ADDENDUM TO THE CONTRACT DOCUMENTS	Page Number 1	No. of Pages 4
Addendum No. One (1)	Date Addendum Issued: February 26, 2026	
Issuing Office Alaska State Parks, Design & Construction Section 550 West 7 th Avenue, Suite 1340 Anchorage, Alaska 99501 Phone: (907) 269-8731 Fax: (907) 269-8901	Previous Addenda Issued None.	
Project: Potter Marsh Facility Improvements Project No.: 91032-2	Date & Hour of Quotes Due: March 5, 2:00 PM prevailing time

STATE OF ALASKA, DEPARTMENT OF NATURAL RESOURCES
 PLANS DEVELOPED BY: DIVISION OF PARKS AND OUTDOOR RECREATION
 550 W 7TH AVE. SUITE 1340, ANCHORAGE, AK 99501 - 907.269.8731
 POTTER MARSH FACILITY IMPROVEMENTS
 PROJECT NO. 91032-2

PILE CONNECTION DETAILS

SHEET
13
 OF 17 SHEETS

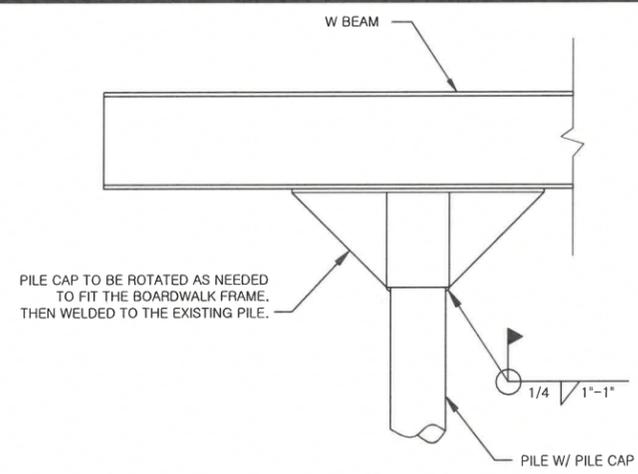
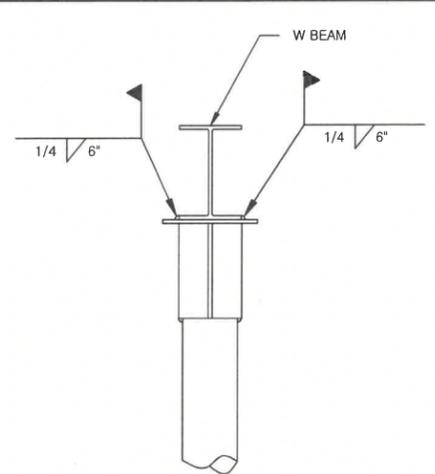
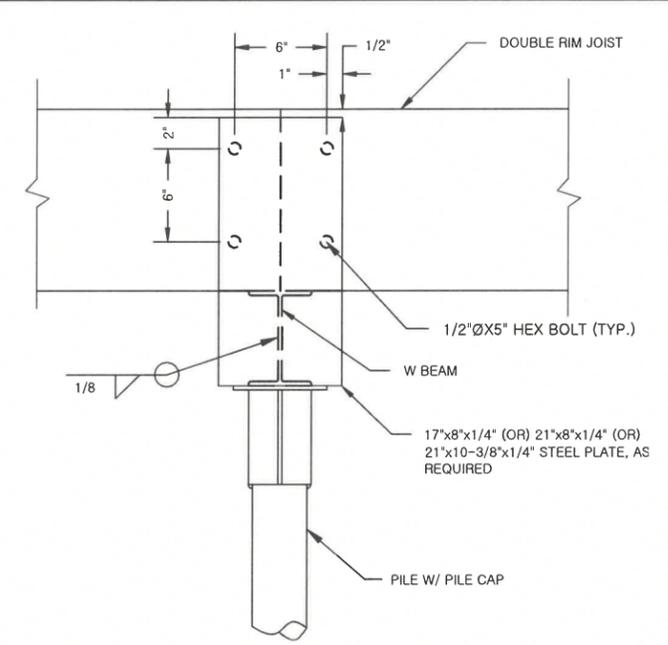
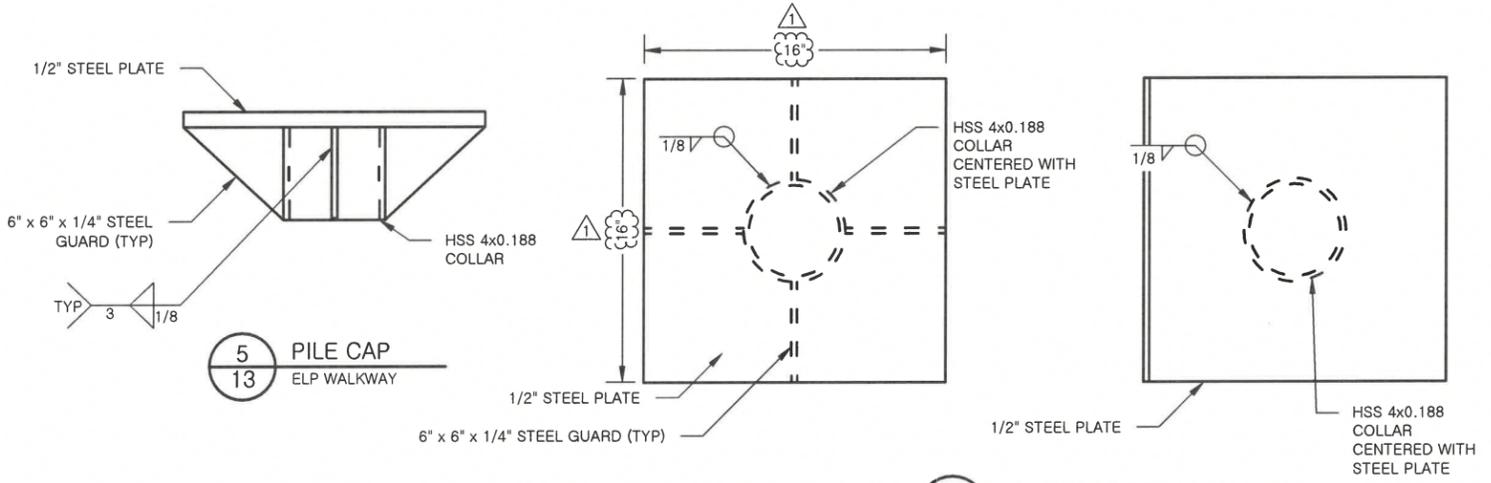
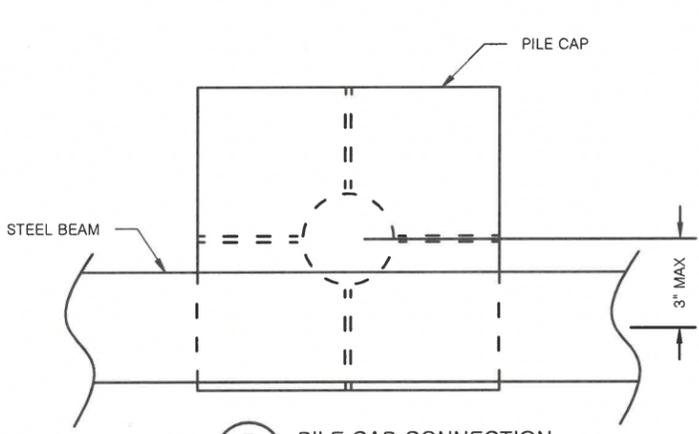
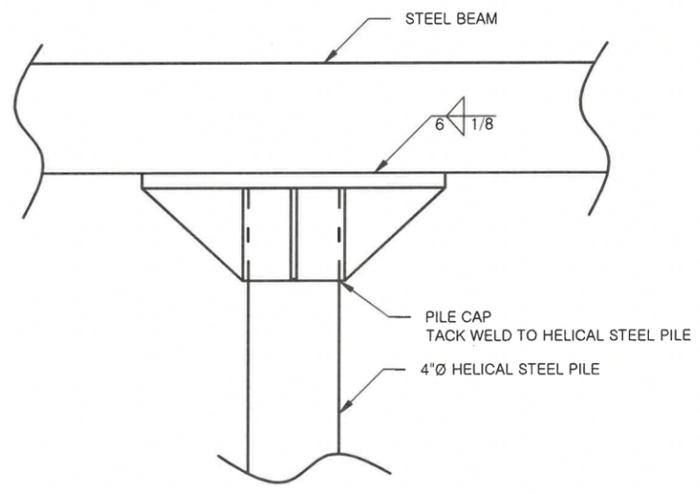
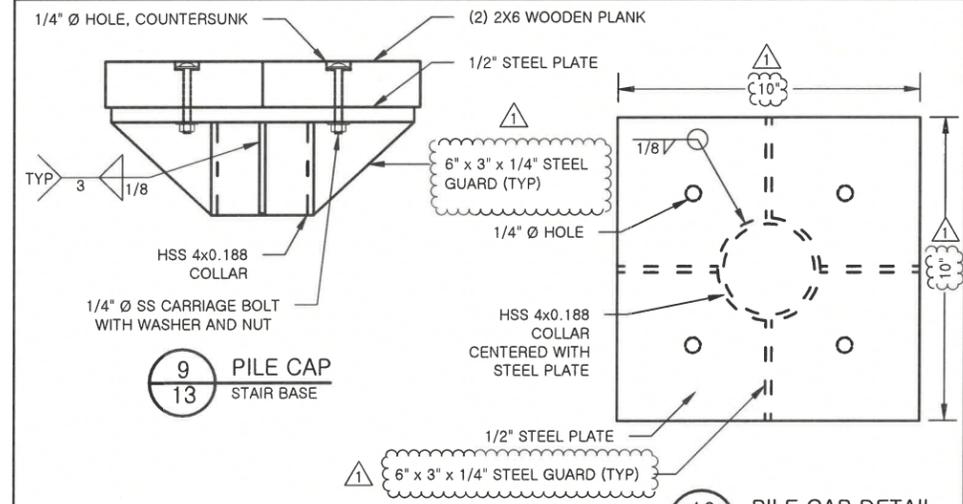
NO.	REVISION	DATE	NOTES
1	ADDENDUM 1	2/26/2026	DIMENSION CORRECTION
